**Section 75W Modification Request  
Subdivision, Plantain Road, Korora  
DA279-11-2004 Modification 1**

Director-General's Environmental Assessment Report  
Section 75W of the *Environmental Planning and Assessment Act 1979*

September 2013

**Figure 2:** Approved subdivision layout under DA279-11-2004

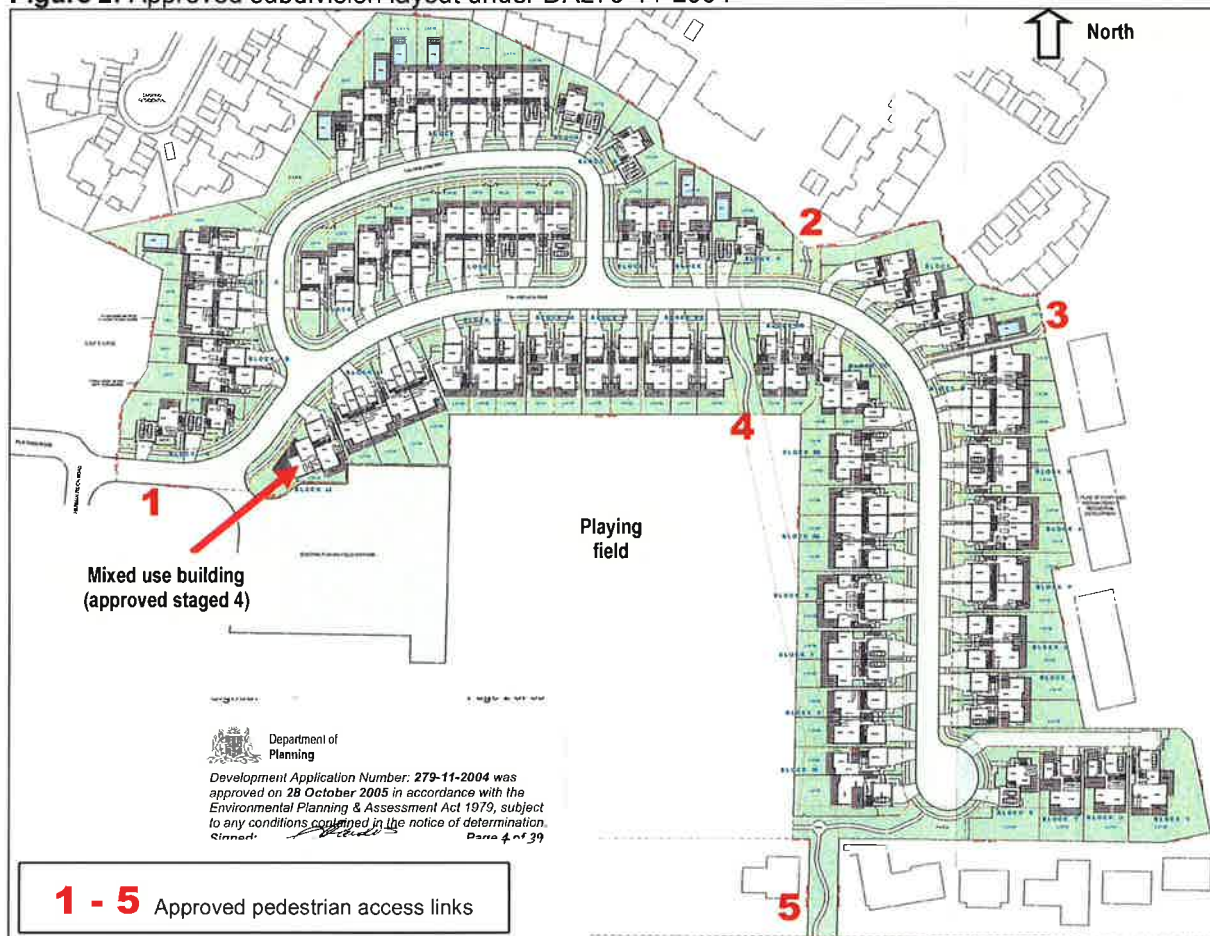
- ii. A pedestrian pathway, over the services corridor, should be provided to the playing field, as required by the existing development consent (link '4' in **Figure 2**).

Link '4' was originally proposed as a common property lot over a services easement and to provide setbacks to either side of the easement that could not be accommodated within the proposed adjoining dwelling lots. The proposed reduction in lot density included in the modification request means the setbacks to the easement can now be accommodated within proposed Lots 45 and 46, either side of the easement. Therefore, a separate lot for the services and easement is no longer required.

On 23 June 2010, Council advised the proponent (**Appendix A**) that the deletion of link 4 (the service easement footpath between Lots 68 and 69) was acceptable, notwithstanding its comment (point (ii) in section 6.2) that link '4' should remain. The deletion of link '4' will mean there is no access to the playing field at this location.

However, alternative access to the playing field is available at the western and southern ends of Road 1, approximately 150 m in either direction of link '4'. The Department considers that the deletion of link '4' is acceptable given those available alternative access points.

**Figure 4: Proposed modified subdivision layout (comprises Stages 3 and 4)**

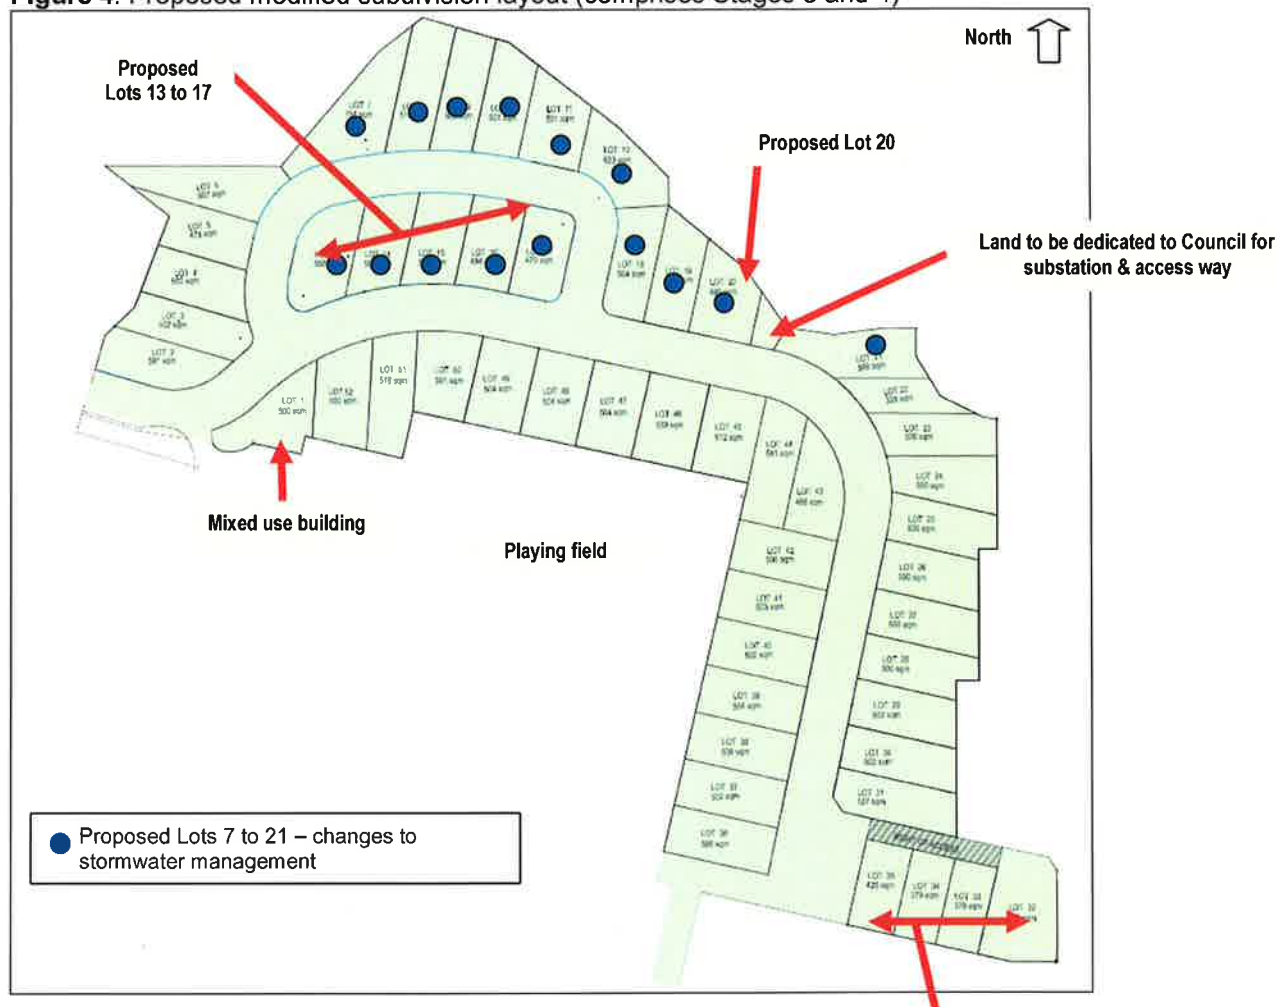
- i. Proposed Lot 20 (see **Figure 3**) appears to be significantly burdened by services and should be absorbed into the adjacent lots. Alternatively, the configuration of proposed Lots 18, 19 and 20 may be reviewed to allow for appropriate building envelopes on each, whilst protecting the infrastructure.

- iii. The residential housing development located on proposed Lots 32 to 35 (see **Figure 4**) is considered unsuitable for Torrens Title subdivision. In this regard, due to the infrastructure and design sharing considerations it would be more appropriate for this development to be strata titled (sharing common areas and a driveway) or community titled (with the common driveway being the community lot).

- iv. Additional development guidelines for proposed Lots 13 to 17 should be provided, given their double frontages (see **Figure 4**). These guidelines should specify to which road future housing development will front and detail fencing controls/heights to rear yards.

In response to Council's point (i) (see section 6.2 above), the layout of proposed Lot 20 (see **Figure 4**) has been amended since both of Council's submissions. The lot is proposed to be 492 m<sup>2</sup> in area, 230 m<sup>2</sup> less than its equivalent approved Lot 32 of 722 m<sup>2</sup>. Approved Lot 32 had a service easement running east-west within the front building setback along the road frontage and one service easement (for sewer) running north-south.

The proponent investigated Council's suggestion to redesign proposed Lots 18 to 20. However, due to individual site sewer infrastructure already installed, the layout needed to remain substantially the same as proposed to avoid sewer lines.

In response to Council's point (iii) in section 6.2, proposed Lots 32 to 35 (see **Figure 4**) are the same as approved Lots 50 to 53, except for the titling. Approved Lots 50 to 53 are strata titled lots with the common driveway being a common lot. Proposed Lots 32 to 35 will be Torrens Title. A common driveway will be provided with a right of access benefiting proposed Lots 32 to 34 (three lots sharing a common driveway), and proposed Lot 35 will have direct road frontage.

Council's Subdivision Development Control Plan requires that subdivision creating more than two lots using a common driveway must be strata or community titled. This is due to concerns about management of letter boxes, waste collection and electricity meters that require public road frontage. The proponent's response to this requirement is that community or strata title management schemes and associated legal complications and costs would be disproportionate and unnecessary to manage waste collection, letter boxes and electricity meters for three lots.

The Department agrees with the proponent's response because mailboxes and electricity meters can be accessed off the common driveway and future residents can take their rubbish bins to the public road for collection. Requiring strata or community titling for three lots is considered excessive and Torrens Title will be satisfactory.
